ADDENDUM No. 03

Date: February 28, 2019

Coaldale Government Building

Project No.: 9030

| | DRG. TITLE : REVISED ELEVATION A AND NEW SECTION 1 | | | |

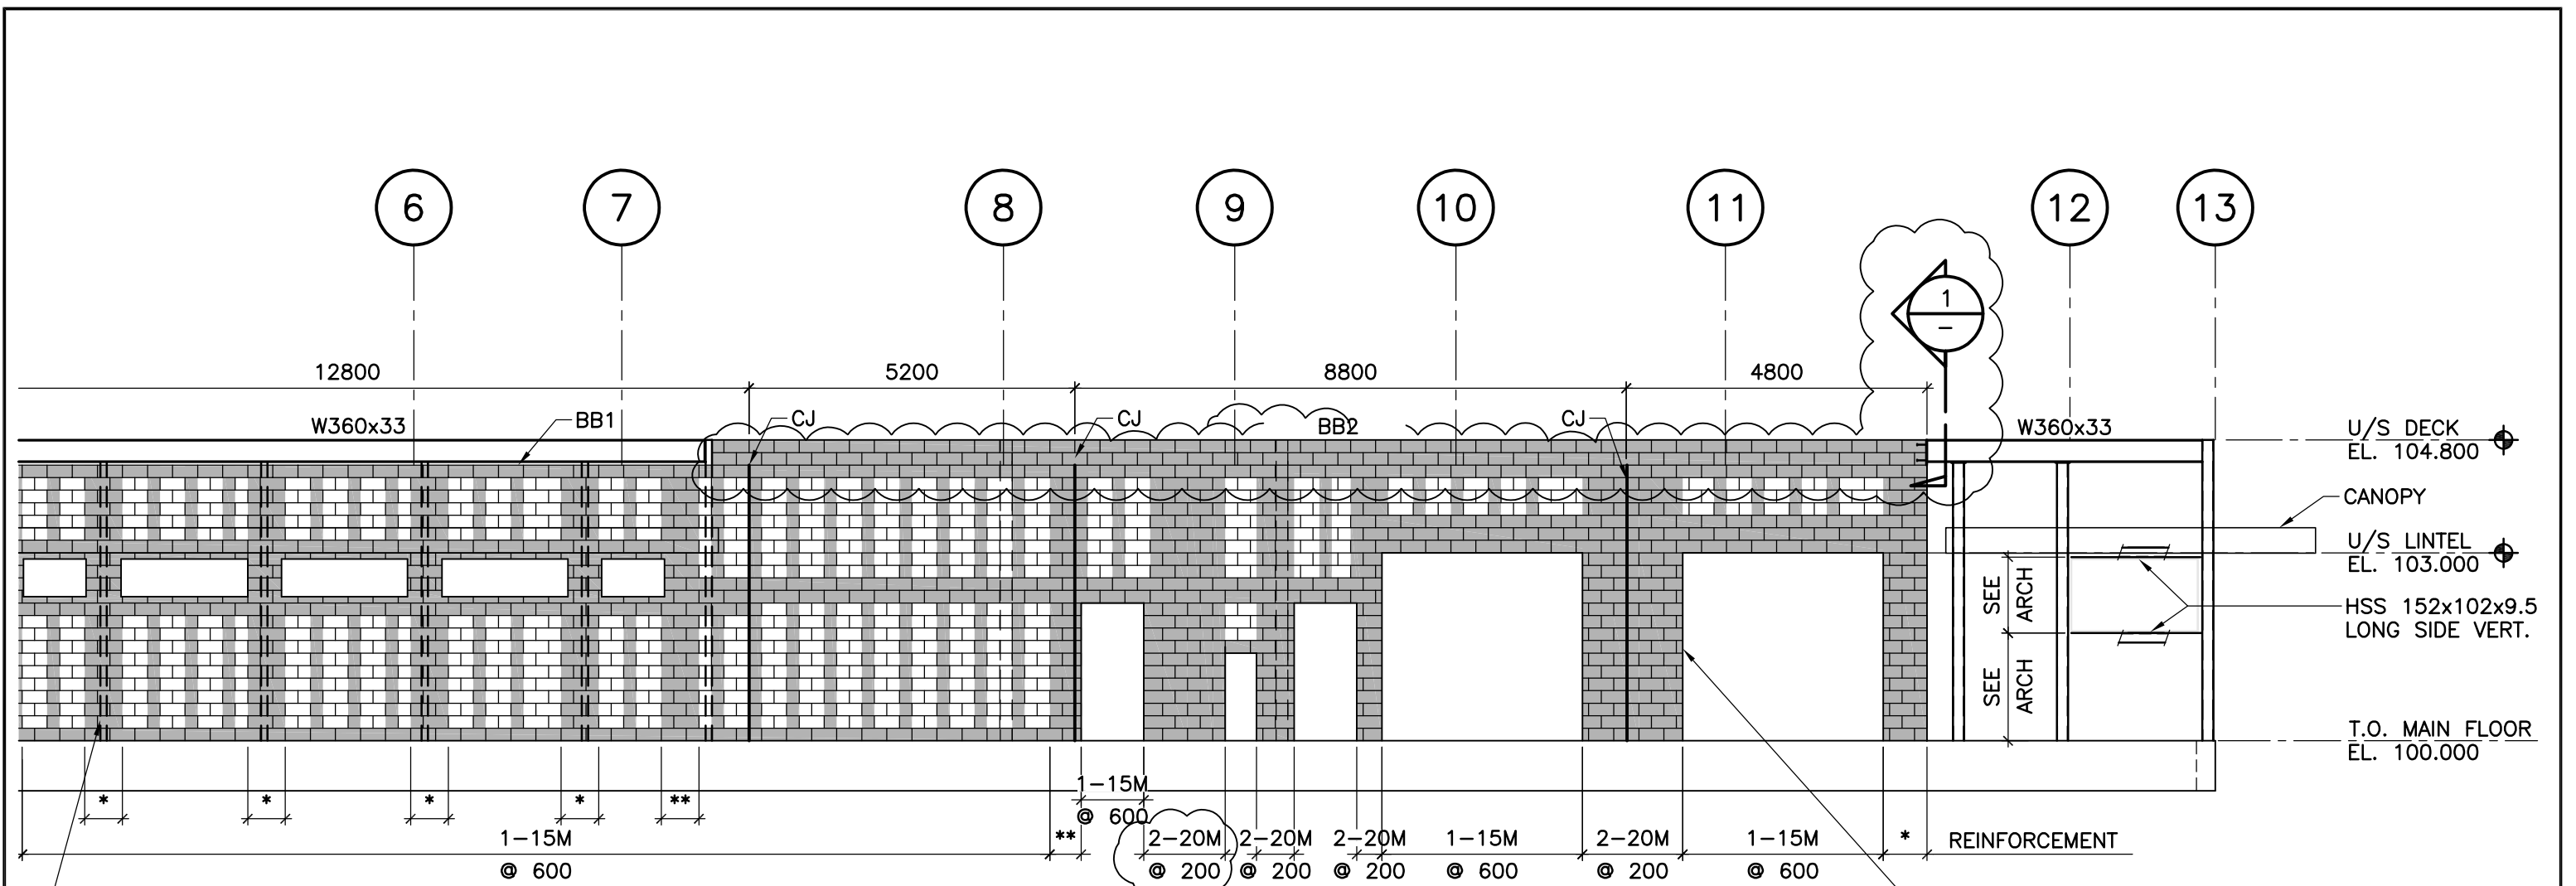
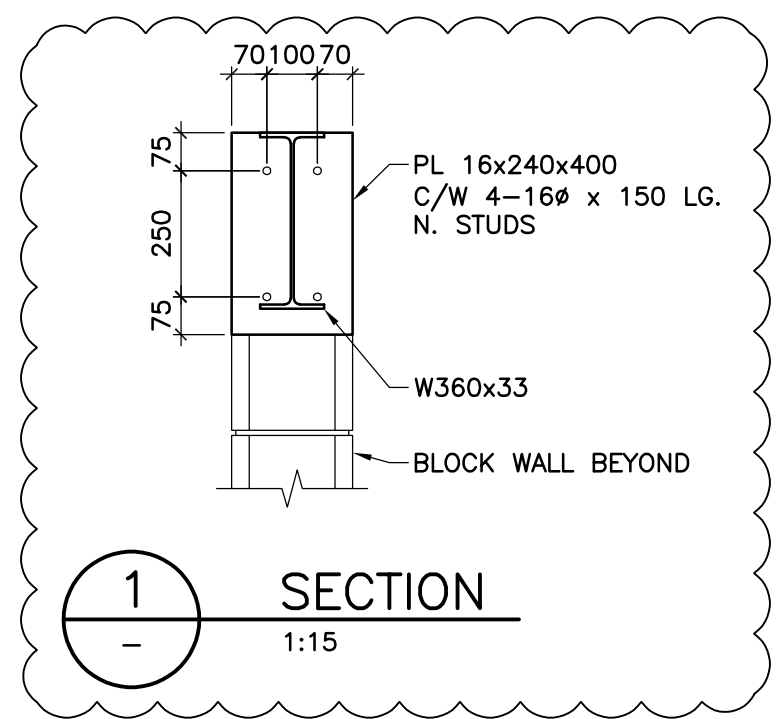
- .8 **Drawing S4.1 Elevations Sheet 1**
 - .8.1 On Elevation A (South), Delete beam W360x33 between gridlines 7 (+1417) and 11 (+3558) and replace with bond beam BB2, which is extended to U/S Deck EL. 104.800 as shown on SSK-039.
 - .8.2 Add section 1 as shown SSK-039.
 - .8.3 Revise reinforcing '2-20M @ 600' to read '2-20M @ 200' between gridline 8 and 9 as Clouded on SSK-039.

**PARTIAL MECHANICAL
FOUNDATION PIPING PLAN
(ADDENDUM M2)**

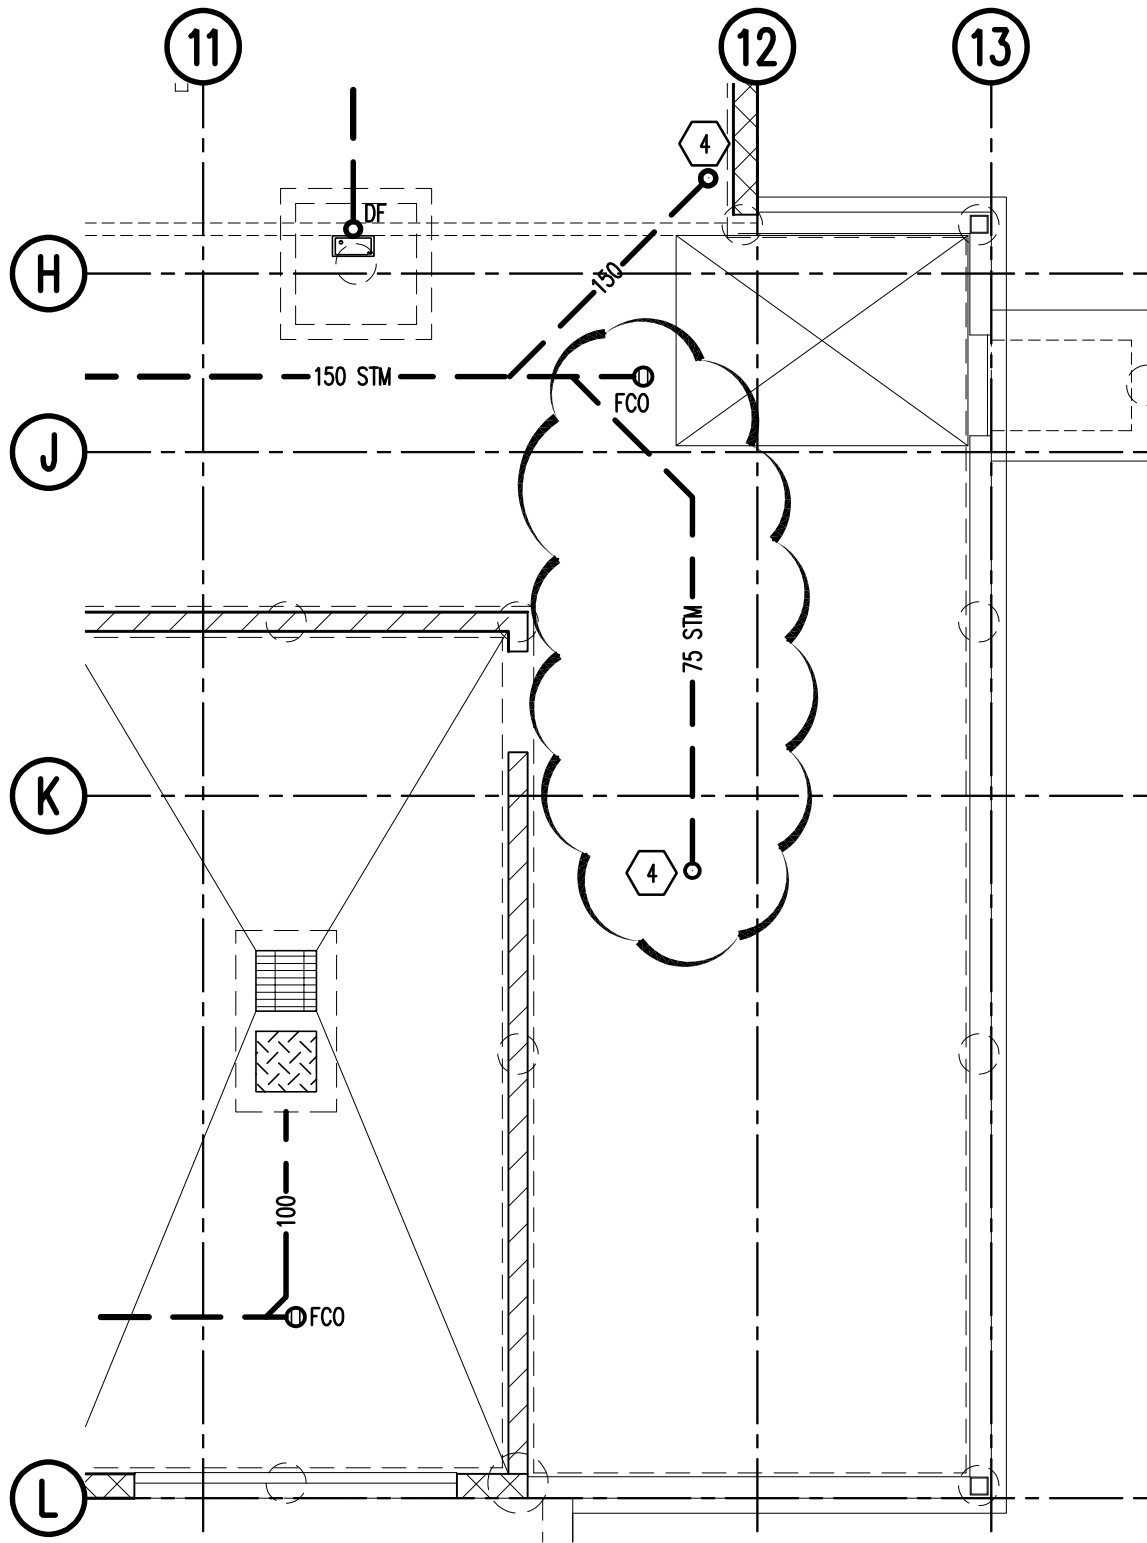
ADD: Add RWL piping as per attached sketch M2.0-MSK-01.

M2.1-MSK-01

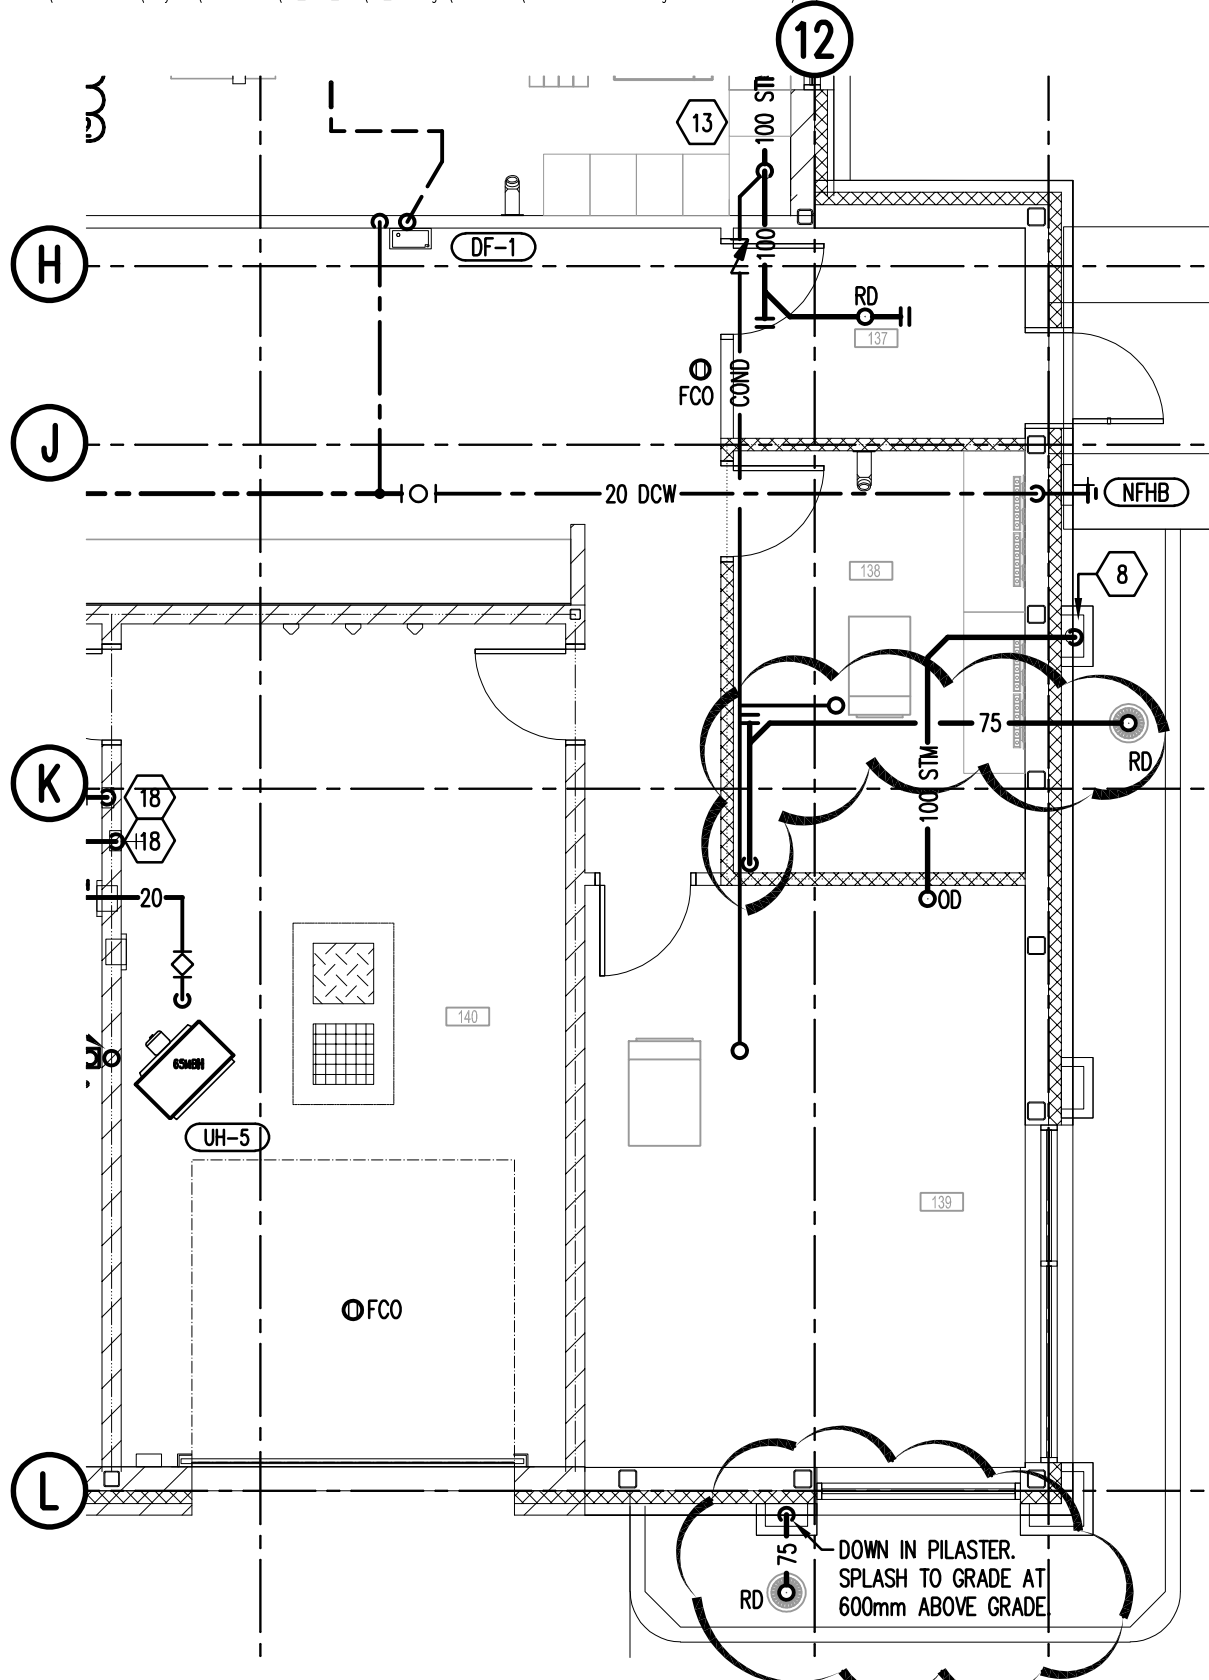
ADD: Add RWL piping as per attached sketch M2.1-MSK-01.

M2.1-MSK-02

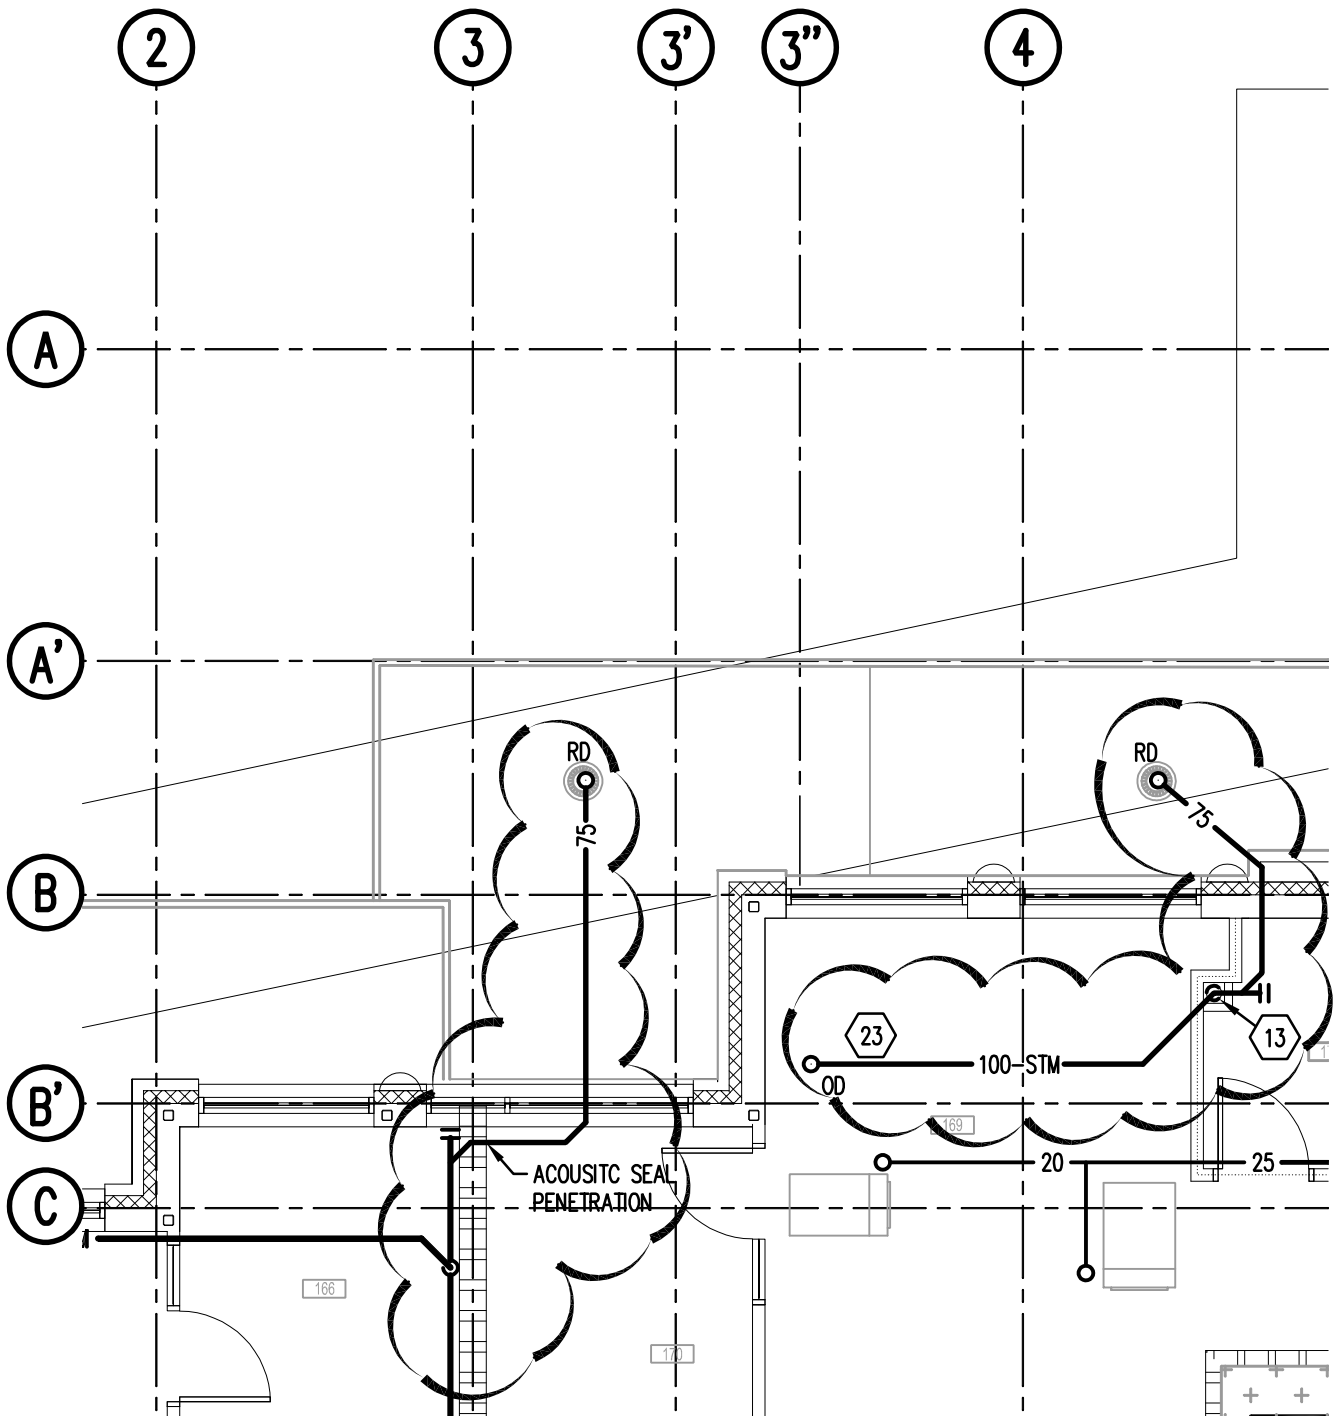
REVISE: Revise RWL piping as per attached sketch M2.1-MSK-02.

M7.0-MSK-01

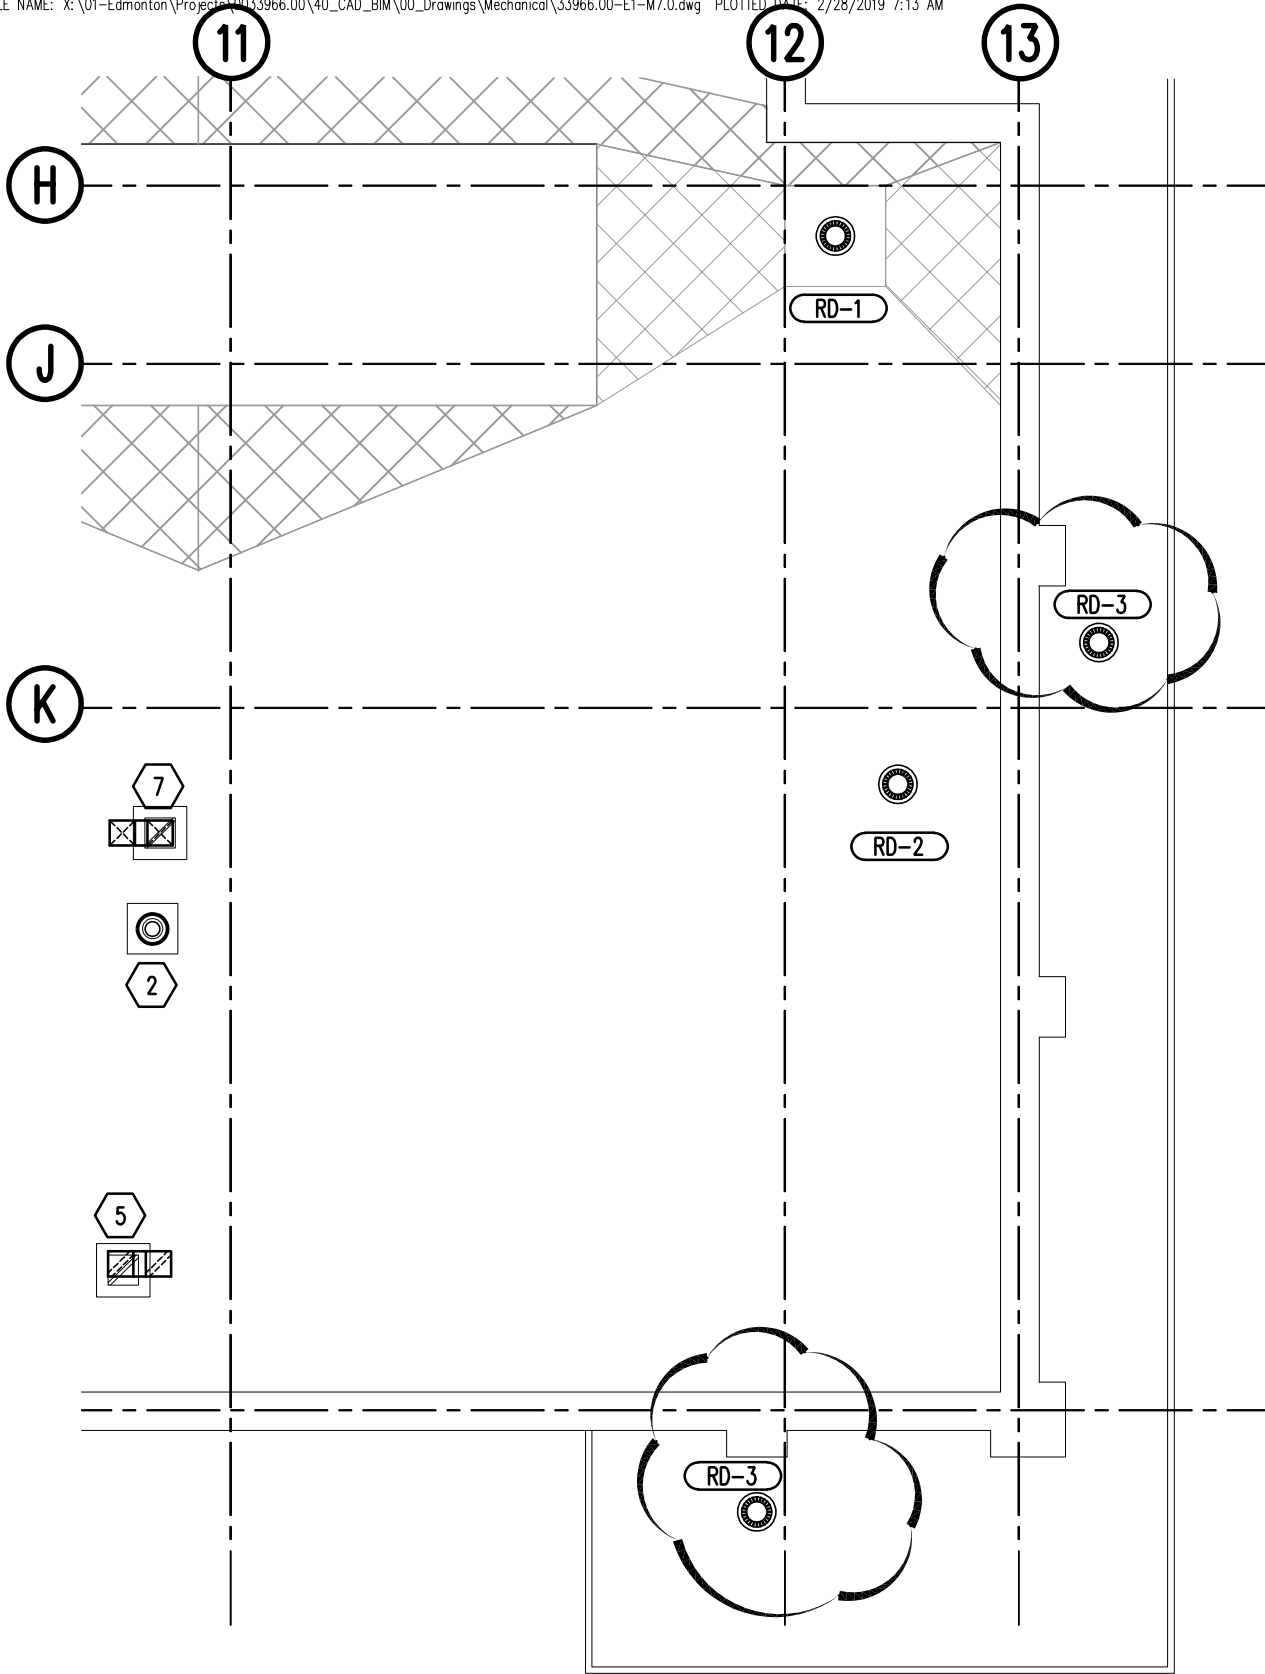
ADD: Add roof drains on southeast canopy as per attached sketch M7.0-MSK-01.
